August 10, 1993

Subject: Michigan Department of Natural Resources Recommendations for

Additional Remedial Investigation Field Work at the Albion-Sheridan

Township Landfill Superfund Site, Calhoun County, Michigan.

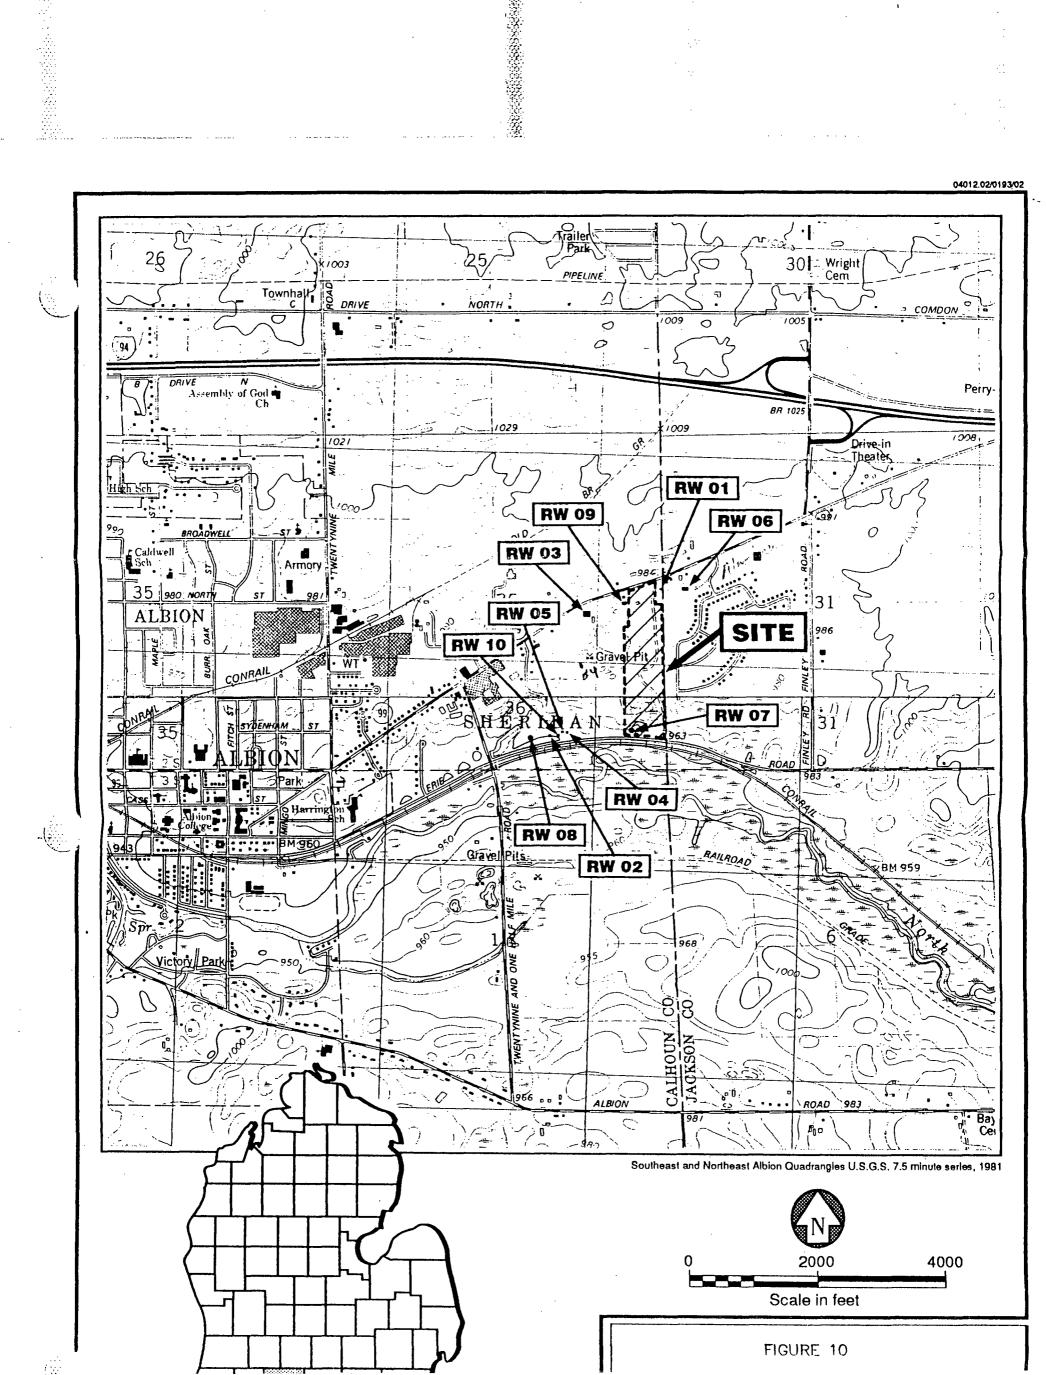
The following comments relate to the map of proposed well nest locations that I have attached to this memo. Generally these locations have been chosen in order to address specific concerns. However, overall we believe that a more complete picture of the site geology, site hydrogeology and contaminate distribution is needed. The present data is insufficient to provide a more complete picture of the site.

Well Nest #1

Well nest #1 is located between the river and the plume to help determine to what extent the bedrock aquifer is discharging to the river.

Well nest #2 is located downgradient of MW9 in order to determine the end of the plume in this direction and to provide more information on the vinyl chloride contamination.

Well nest #3 is located approximately downgradient of MW* in order to determine the extent of the plume in this direction, to provide more information on the vinyl chloride contamination in this direction and to provide more hydrogeologic information on the mounded or perched aquifer in this area. Additionally, it will help better define the hydrogeologic characteristics of the weathered bedrock and bedrock aquifers in this area. We are uncertain of how far the influence of the major pumping wells extends toward the site.

Well nest #4 is located on the other side of, or near the center of, a potential groundwater divide. We feel it is important to insure that no undetected contamination is moving toward the Orchard Noll area. Additionally, a nest of wells in this area would provide data that would help fill a major gap in our understanding on the groundwater flow away from the site.
